Technical Service Bulletin

Cobra Motorcycle Mfg.

TSB2112 CX65 Power Valve Gasket

June 7, 2012

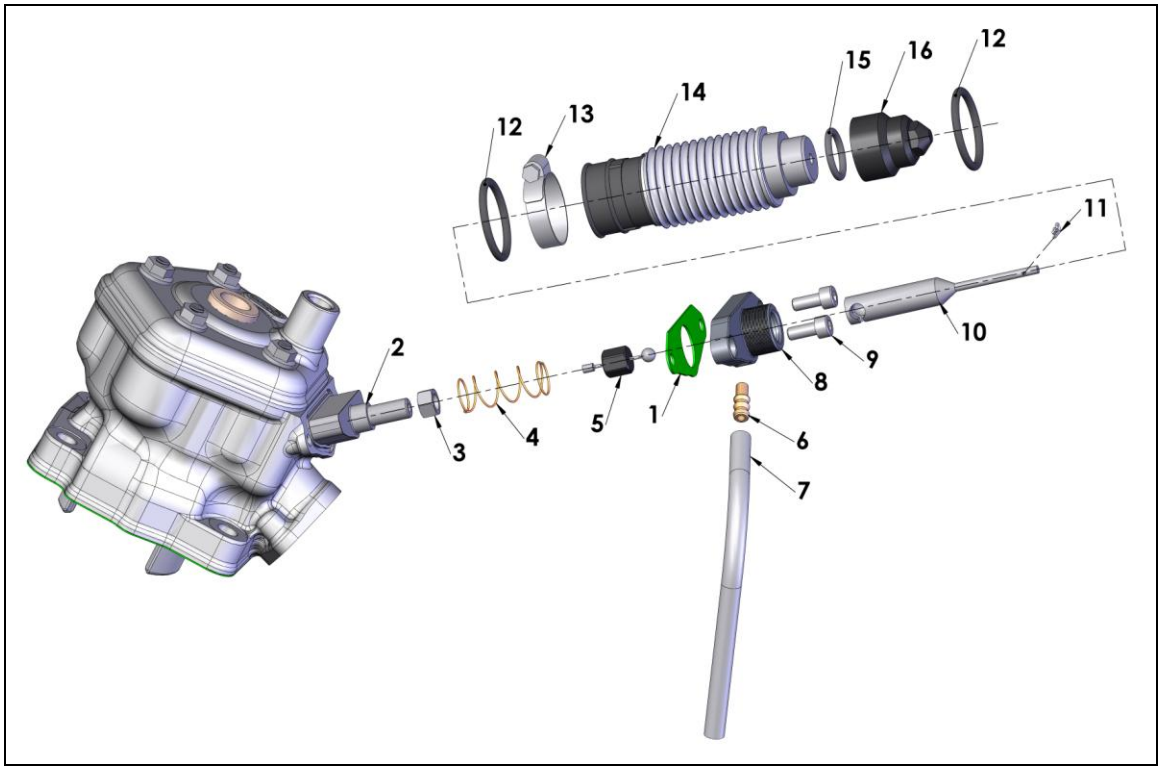
As of today, Cobra CX65 will be built with a gasket between the cylinder and the valve cap instead of the o'ring (item #1 in the figure below). The gasket part number is ZCC60012. It can be used along with the o'ring.
